Re: New Catherine Field Primary School, O'Keefe Drive, Oran Park (SSD-9477)

MEMORANDUM

CATHERINE FIELD PS
NEW HIGH QUALITY CLASSROOMS
DRAWING NAME
OVERALL SITE PLAN

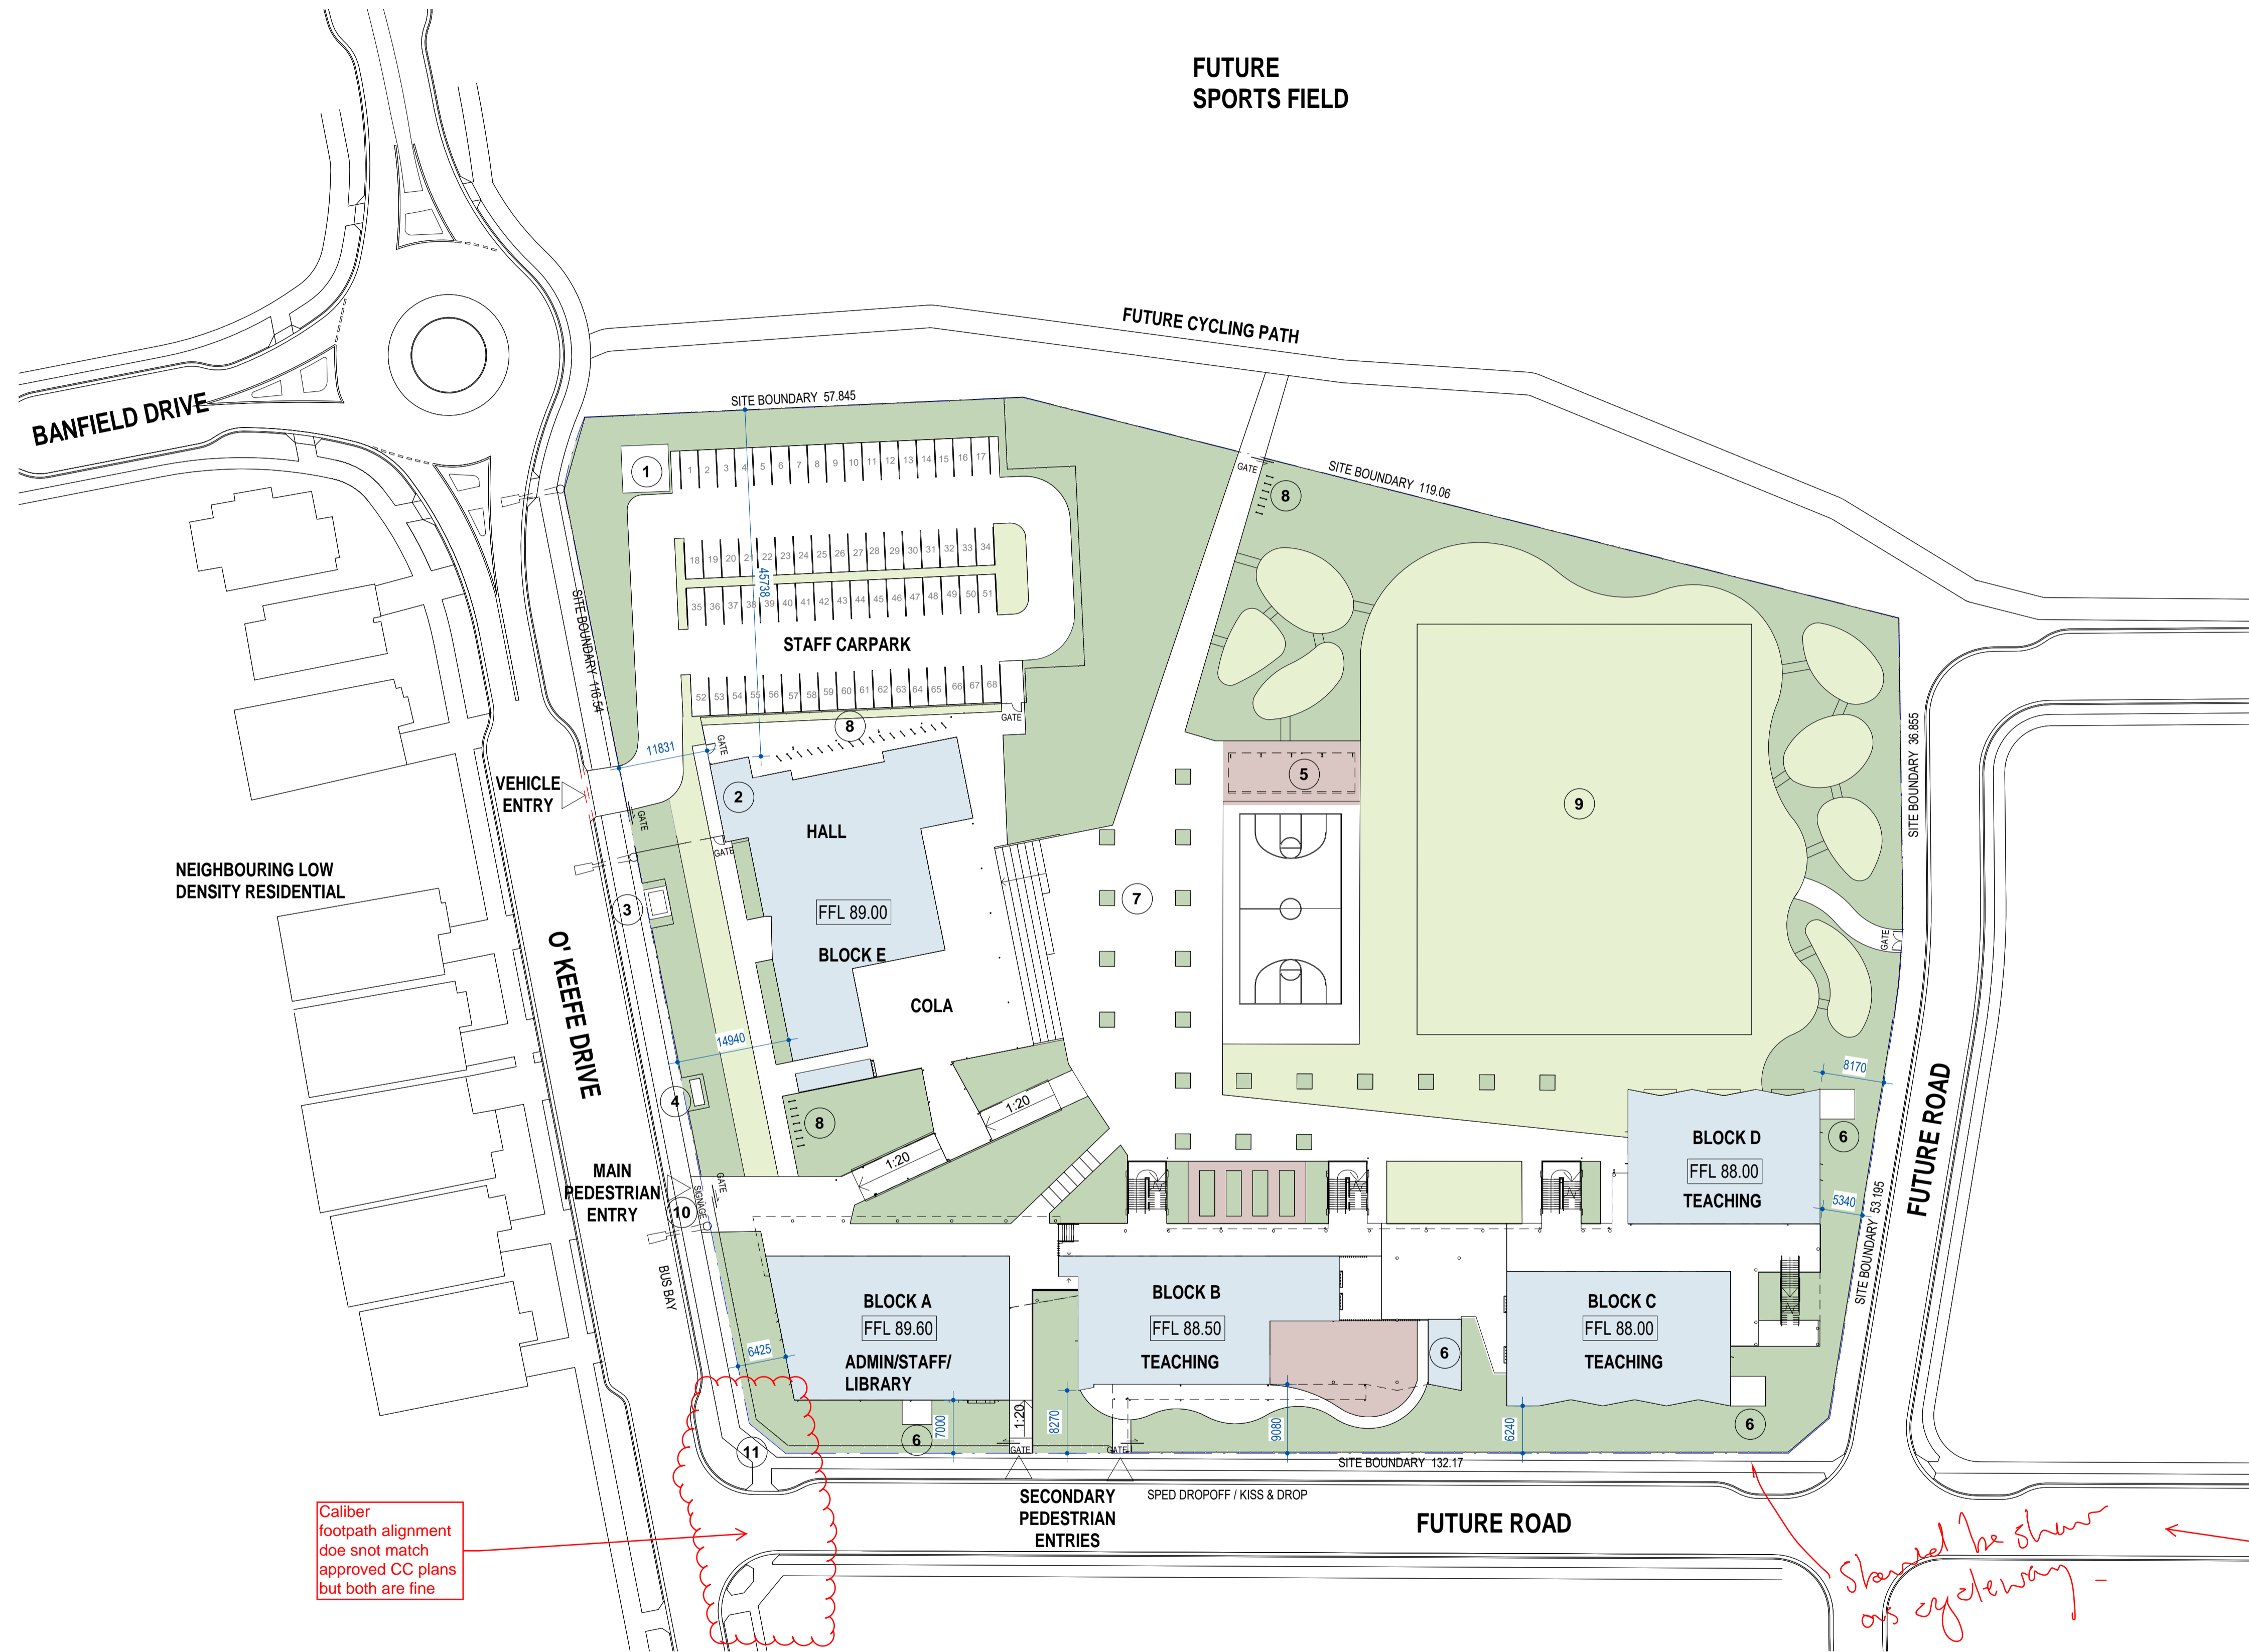
Caliber
footpath alignment
does not match
approved CC plans
but both are fine

Should be shown
as cycleway -

Calibre
Approved Stage 6
plans only have
1.2m wide
footpath.

Figure 19: Shadow at 21 June 9 AM

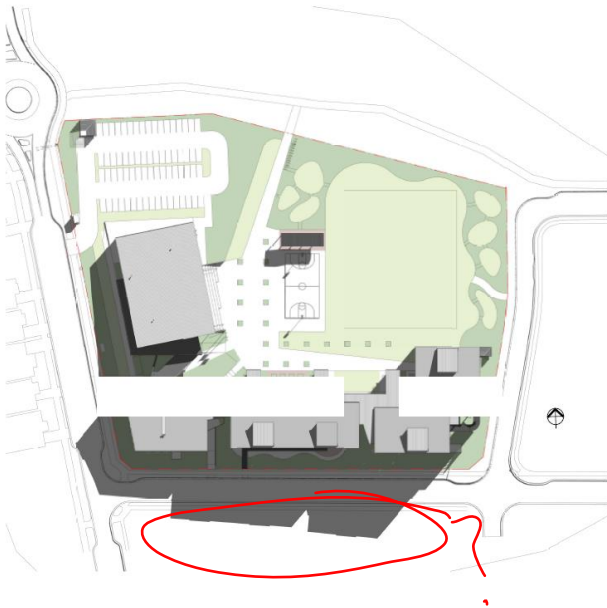
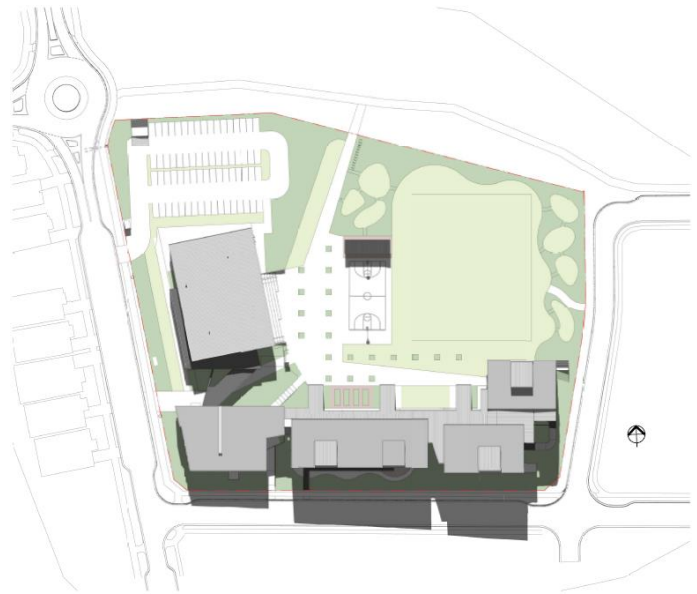
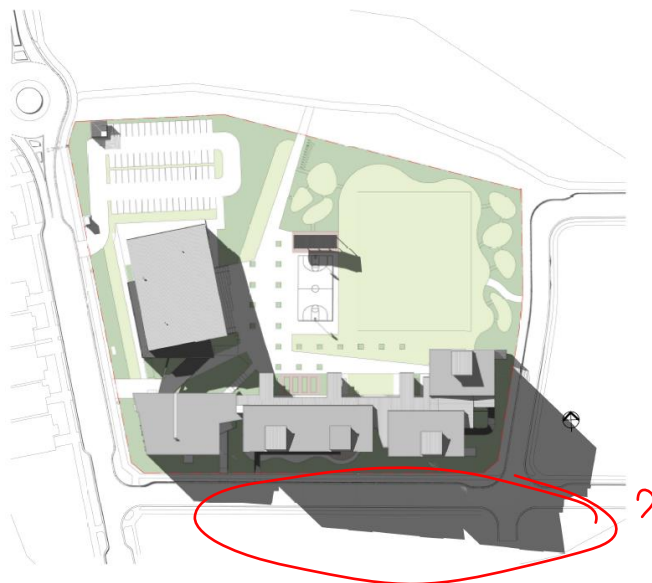
NOTE THAT
BUILDING HEIGHTS
DON'T COMPLY.
